In Reply Refer To:
HSST/WZ-323

Name of system: DF3003W stand with 60x60 rectangular signs
Type of system: X-Footprint Portable Sign Stand
Test Level: NCHRP Report 350 Test Level 3
Testing conducted by: N/A
Date of request: January 28, 2013

Request for Federal Aid Reimbursement Eligibility Of Highway Safety Hardware

This inquiry is a follow-up to WZ-294 regarding the impact 60x60 roll-up signs would have on previously accepted stands. Based on the clarification provided in WZ-85, various sizes of roll-up signs can be accepted without re-testing. One key criteria involved the finished sign height, specifically that the bottom of the sign be no closer than 12" to the ground. In this application the proposed 60x60 signs would only be mounted in a rectangular configuration. The stand / sign specifications may be found in Table #1 below and in the attached drawing.

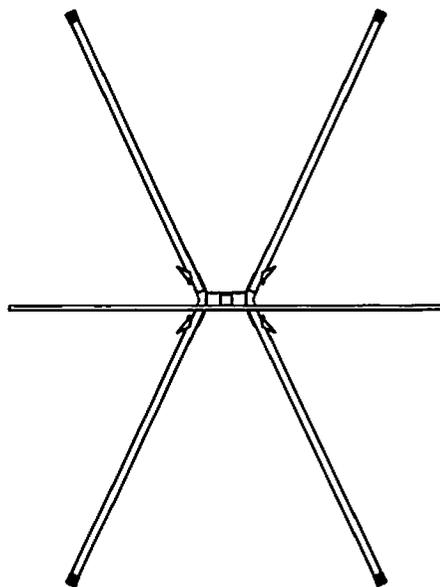
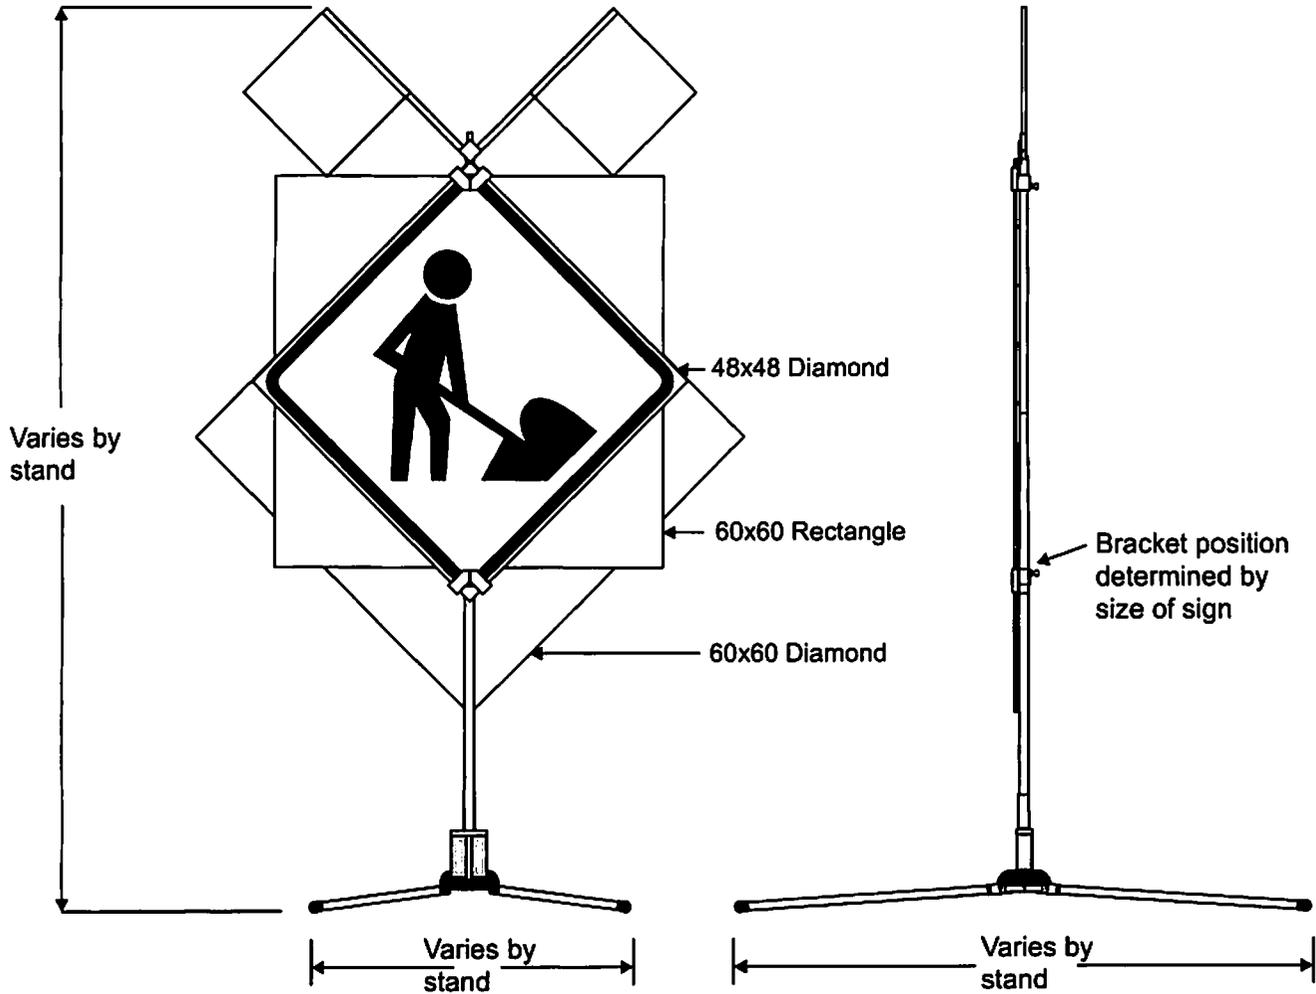
Based on the enclosed information and previous test data, we are seeking acceptance of the DF3003W stand listed above for use with 60"x60" roll-up signs. We believe this to be a reasonable request because the key design features are almost identical to the previously accepted TF18 stand. As such, we contend that there will be no effect on the windshield impact data.

The device and supporting documentation are described in the attached form. This action permits the use of 60 x 60 inch rectangular signs to the crash tested stand listed above. Critical dimensions relating to impact location near the windshield are the same as the crash tested stand.
